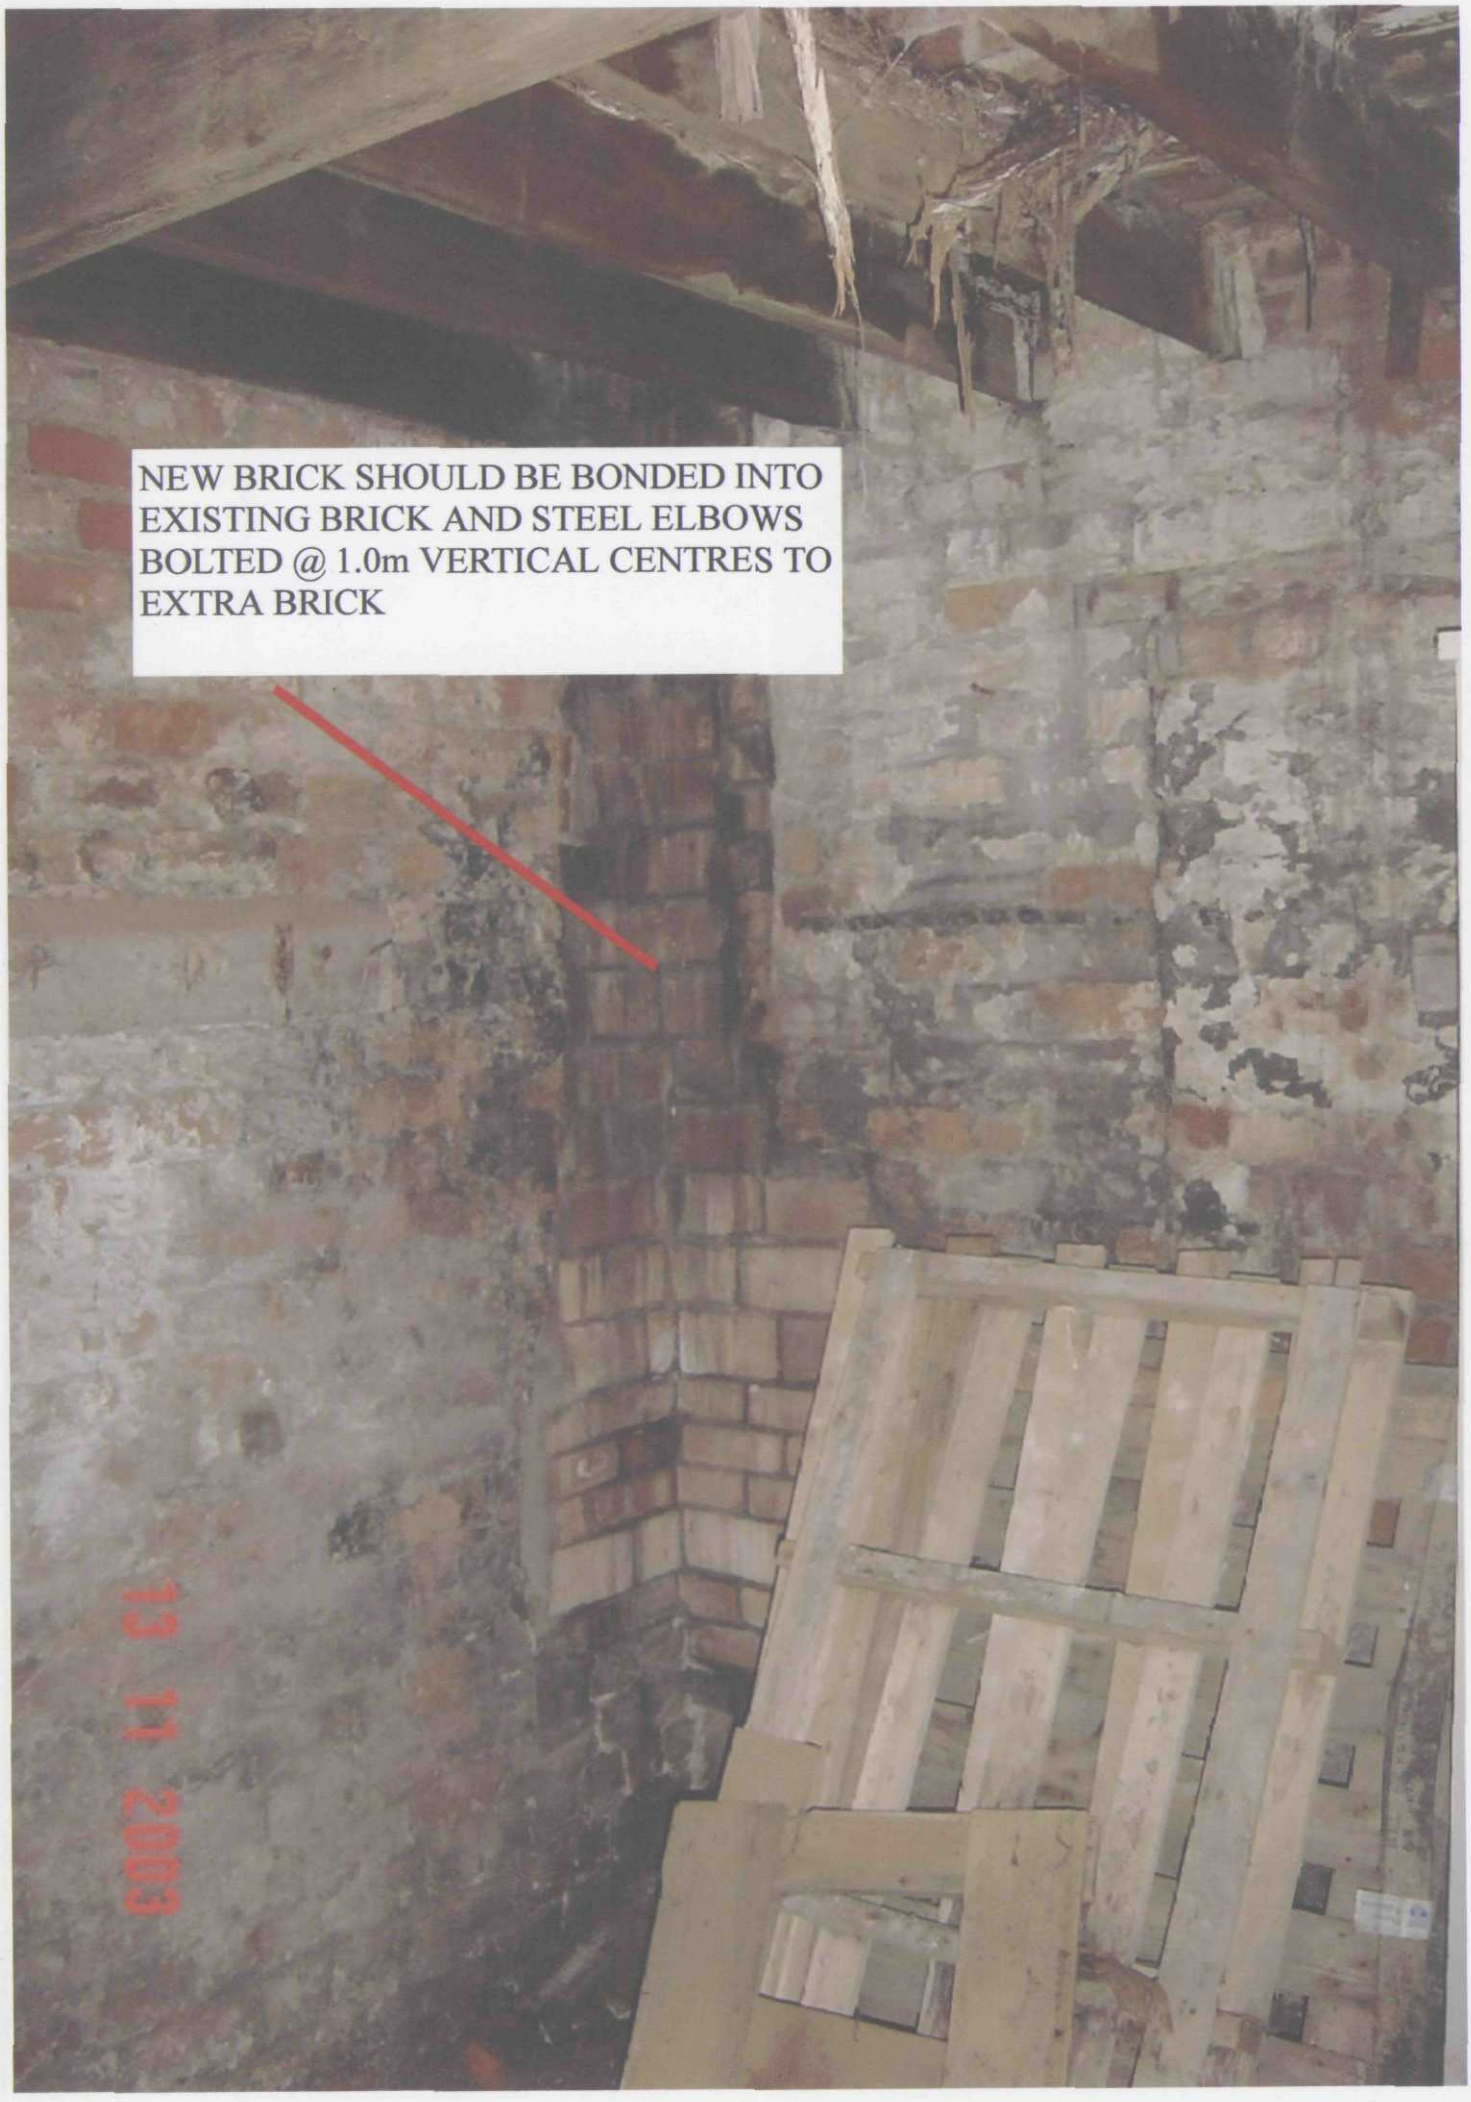
NEW BRICK SHOULD BE BONDED INTO EXISTING BRICK AND STEEL ELBOWS BOLTED @ 1.0m VERTICAL CENTRES TO EXTRA BRICK
13 11 2003
